IDAP REPORT

Property:	175 Albert Road STRATHFIELD Lot: 21 DP: 590192 DA2021.140
Proposal:	Demolition of existing building and construction of a two (2) storey dwelling house with basement.
Applicant:	Minto Planning Services
Owner:	ZC Ding & R Zu
Date of lodgement:	17 June 2021
Notification period:	29 June – 13 July 2021
Submissions received:	One (1) submission in support of the application.
Assessment officer:	L Gibson
Estimated cost of works:	\$627,471.00
Zoning:	R2-Low Density Residential - SLEP 2012
Heritage:	No
Flood affected:	No
RECOMMENDATION OF OFFICER:	APPROVAL

Figure 7: Original landscape plan showing proposed removal of 8 trees through the site.

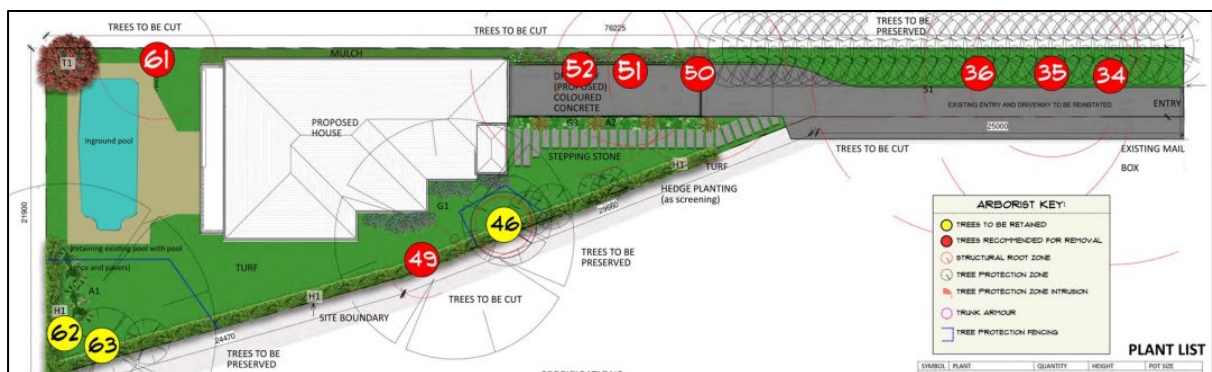
- More information is required in the Arboricultural Impact Assessment report on the retention of the neighbouring trees (173 Albert Road) along the existing driveway.
- **Trees 50, 51 and 52** are required to be removed for the proposed basement / ramp. Additional tree planting is required in the front of the property and along the driveway of the dwelling. This is to be submitted in a revised landscape plan.

The proposed development originally involves removal of eight (8) site trees through the site (refer to Figure 7 below). Council's Tree Officer did not support the removal of trees 34 and 35, thus amended plans and documentation were submitted during the assessment process to demonstrate the retention of trees 34 and 35.

Amended plans and documentation were submitted to Council during the assessment process to resolve the above concerns. Council's Tree Officer had no further concerns subject to conditions of consent.

Figure 8: Amended landscape plan showing retention of trees 34 and 35.

Figure 9: Proposed basement plan.

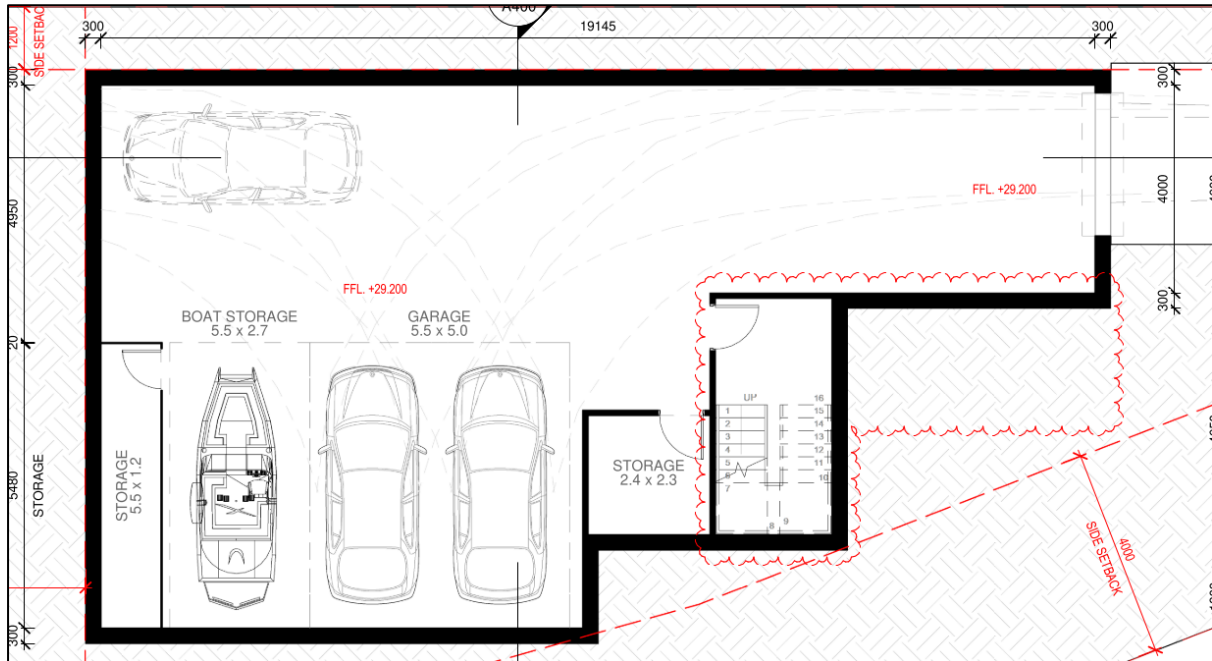
The basement design and size has been revised throughout the assessment process to achieve a reduced footprint which fits within the building envelope of the ground floor of the dwelling. Whilst the basement still provides 3 off-street parking spaces, this has been taken into account to determine overall floor space for the site. The proposal is compliant in this regard. The basement is 400mm above NGL providing an internal minimum clearance of 2.5m. Vehicles are capable of entering and exiting the basement in a forward direction with plans demonstrating compliant vehicle maneuvering circles.

| 28 July 2021 | A revised basement plan was submitted to Council demonstrating compliance with Council's DCP basement and parking requirements. |
